## Responses to reviewers – ESSD-2024-420

**“Global ocean surface heat fluxes revisited: A new dataset from maximum entropy production framework with heat storage and Bowen ratio optimizations”**, by Yong Yang, Huaiwei Sun, Jingfeng Wang, Wenxin Zhang, Gang Zhao, Weiguang Wang, Lei Cheng, Lu Chen, Hui Qin, Zhazhang Cai, submitted to *Earth System Science Data*.

## Responses to Reviewer #2

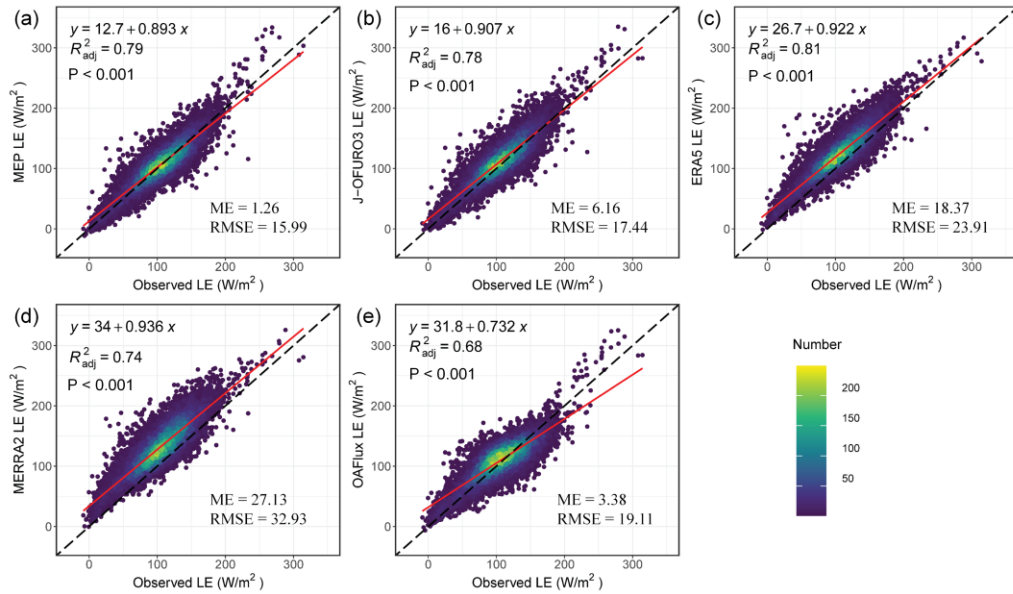
(26) Figure 8: Add p-values here as well.

**Response:** Thank you for pointing this out. According to your comment, we have added p-value ( $p < 0.001$ ) in the Figure 8 as:

**Figure 11.** Spatial distribution of multi-year trends in ocean evaporation estimated by the improved MEP method during (a) the period 1988-2017, (b) the period 1988-2003, (c) the period 2003-2017, and (d) the latitudinal average changes across three different periods.

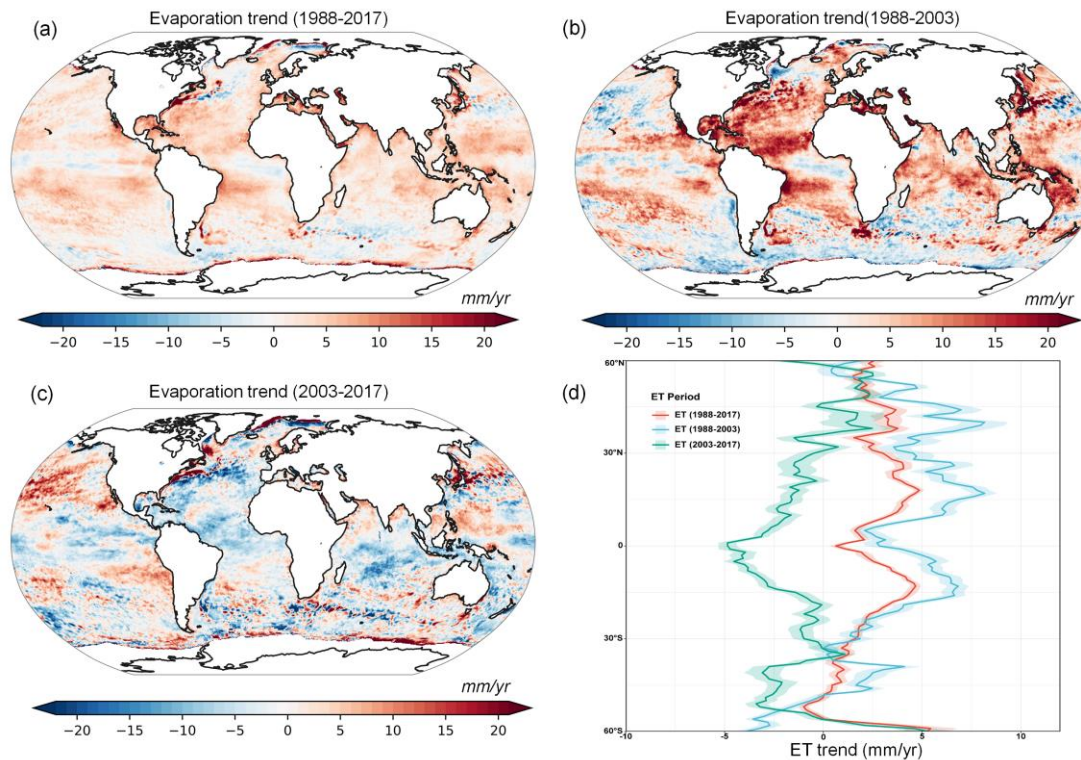
(28) Figure 11: Please confirm the trend legend colors used are consistent with the map colors.

**Response:** Thank you for pointing this out. The reviewer 1 also pointed out that the spatial-temporal variability of ocean evaporation should be analyzed at two separate periods. Therefore, we have revised the Figure 11 to include more result. Also, we have made sure that the trend legend colors used are consistent with the map colors. The revised Figure 11 is as:
